re: City Commission work session, E. 9th St., 14 March 2017

E. 9th St. – Brick Concept Plan

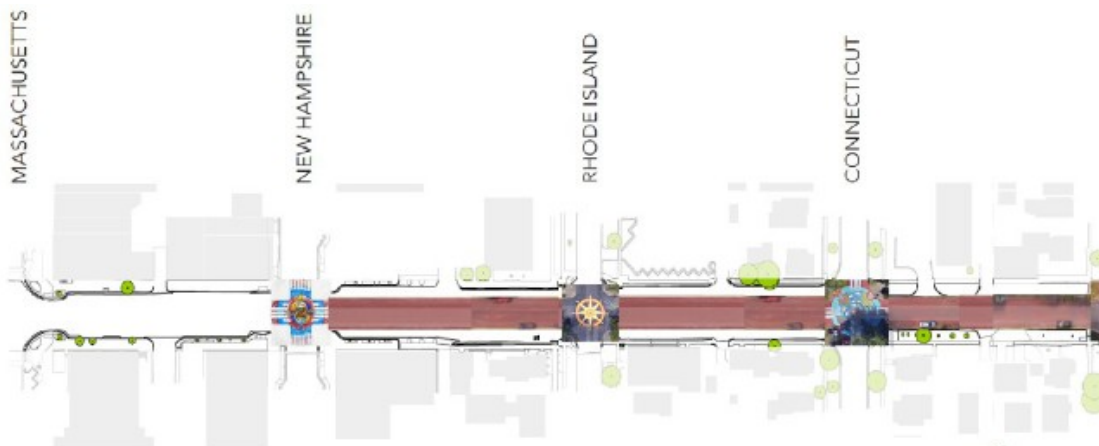
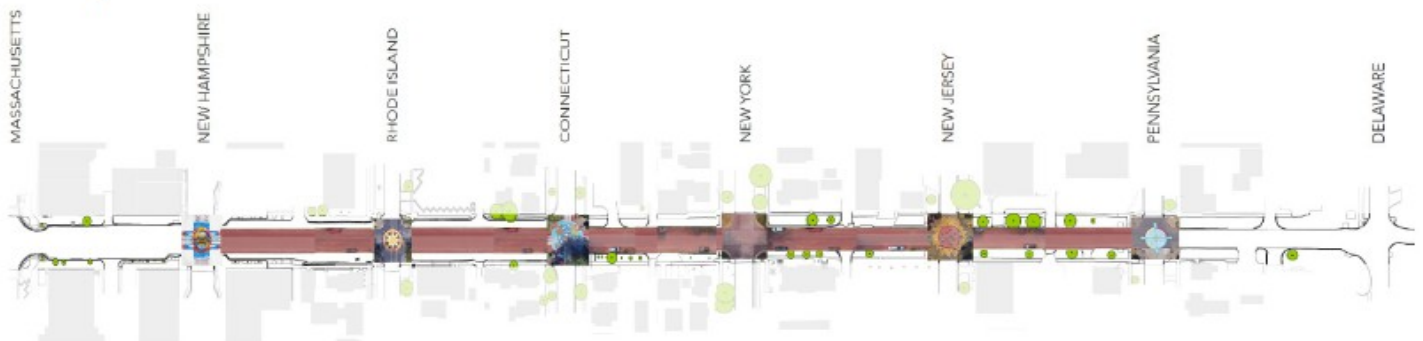
Option two: brick herringbone pattern street (preferred option)

Repaving E. 9th St. 30 feet wide with bricks, from Pennsylvania St. to New Hampshire St., would be inherently traffic calming, would conform to other historical East Lawrence brick streets, and would cost essentially the same as the current Public Works proposal. The Commission saw this design when I presented it at the work session on 12 July 2016. It is duplicated below.

An essential element to make this design bicycle friendly is that the bricks be laid on a herringbone pattern, for smooth rolling. The intersections would be concrete, and painted (or concrete colored) as “intersection art”. Local artists would design and be paid for this art. Estimated project costs would be \$1,941,500. However, if engineering and contingencies are calculated at 10% in keeping with the current Public Works proposal, the brick option cost comes in at \$1,664,000. Please see design schematics below.
